MACK TRUCKS, INC.
2100 MACK BOULEVARD
P.O. BOX M
ALLENTOWN, PA 18105-5000

**SAFETY RECALL SC0321
MARCH 2007**

PROCEDURES FOR INSPECTING THE BRAKE PEDAL PIVOT

Figure 2 — Inspecting Brake Pedal Clevis Pin

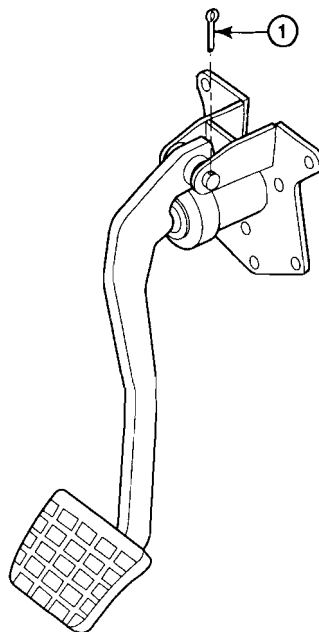
SAFETY DEFECT: There exists the potential that the cotter pin that retains the brake pedal clevis pin may not have been installed.

SAFETY RISK: The clevis pin connects the brake pedal to the brake foot valve; therefore, if the pin were to come loose, the driver would not be able to apply the service brakes, which could result in a vehicle crash.

3. Inspect the brake pedal clevis pin for the presence of a cotter pin. If a cotter pin is not present, insert a new pin (part No. 29AX3) into the hole at the one end of the clevis pin, and then bend the ends of the cotter pin around the clevis pin.

Key	Qty.	Part No.	Description
1	1	29AX3	Cotter pin, 3/32" x 1" long
